**1 Products affected**

Product Change Notification					PCN EC11-New Connections		
owner	creation date	release date	released by	change order	rev	page	D10-067-746
huberth	02.09.2022	12.09.2022	muehlema	2024666	A	1 of 2

Current product appearance	New product appearance

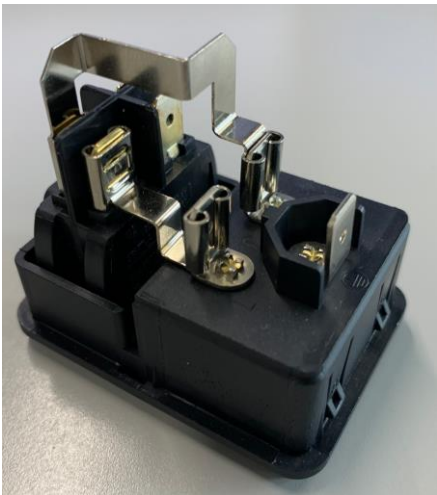
- Wire connection between inlet and switch replaced by brass brackets

- Improved assembly process
- Lower installation depth

Verify installation dimension and check insulation requirements.  
If required use rear cover RC 320-07 (Article 3-125-667).
